**Opti-Flow™ Low NO_x Burner
Operating Instructions**

Elbow Burner

From: "Salvatore Ferrara" <sal@advancedburner.com>
To: "Jerry Finlinson" <Jerry-F@ipsc.com>
Date: 12/22/2003 3:15:40 PM
Subject: Contract 04-45606, Scanner System Change Request

From: "Salvatore Ferrara" <sal@advancedburner.com>
To: "Howard Hamilton" <howard-h@ipsc.com>
Date: 2/9/2004 11:20:11 AM
Subject: FW: Questions and requests Concerning the removal and installation of the existing B&W Oil Igniter

IP7_030338

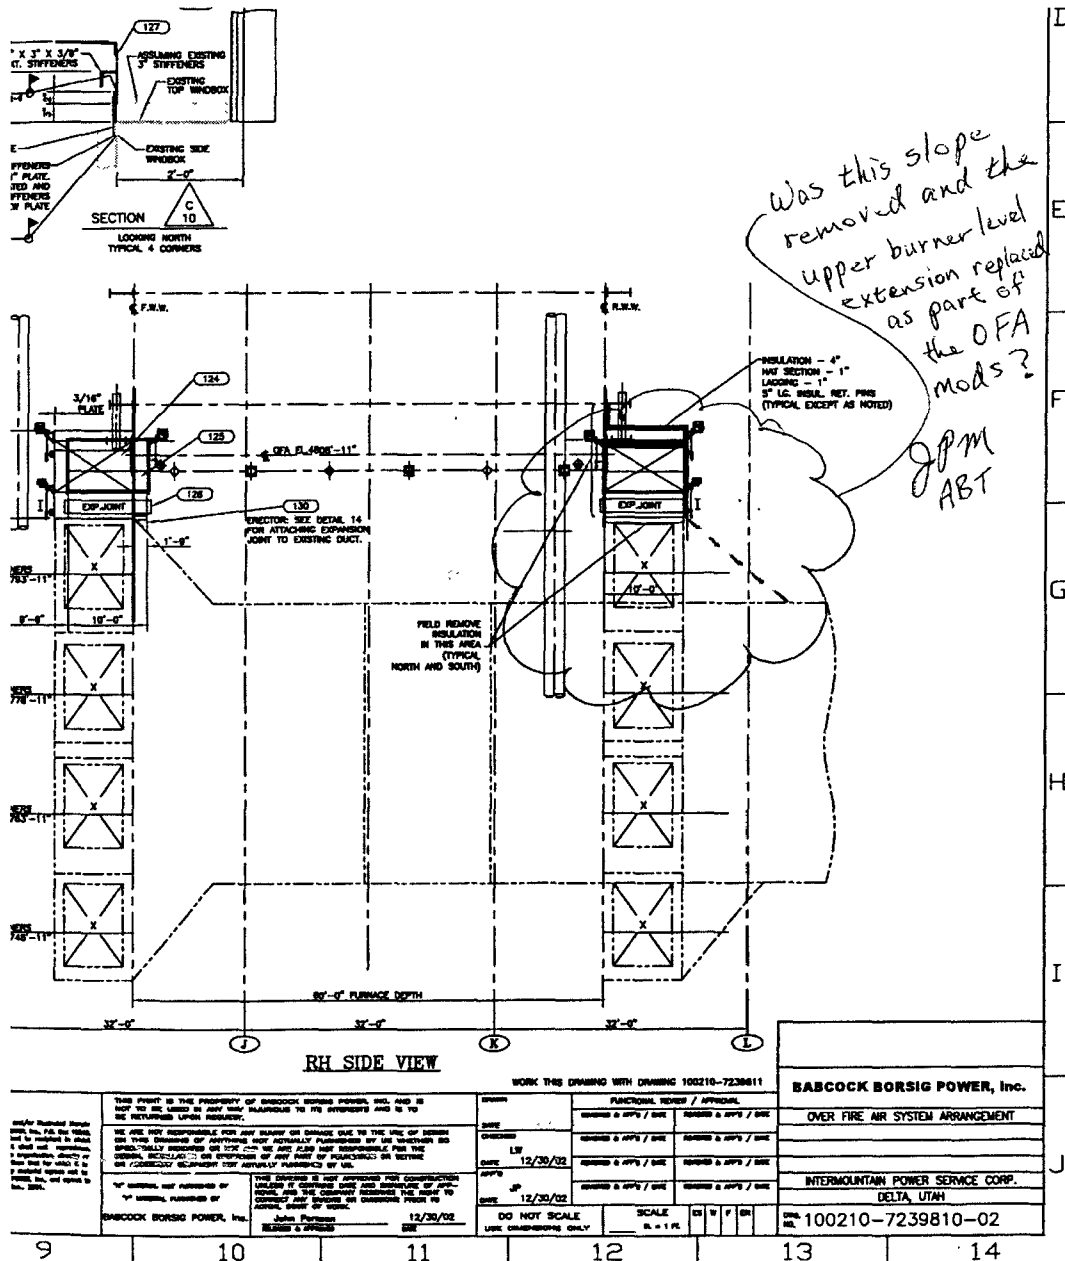
In reviewing the flow model geometry for the secondary air ducts, overfire air ducts, and windboxes a few questions came to light:

1. The overfire air arrangement drawing, a section of which is shown below, does not show a sloping duct leading up to the rearwall overfire air duct. I sketched in a dashed line to show where the slope used to be. The OEM drawing of the secondary air duct arrangement (Ref. OEM drawing: 405864E) shows the slope and a narrower vertical extension. Was the slope removed and the vertical

extension coming off the top of secondary air duct replaced as part of the overfire air modifications?
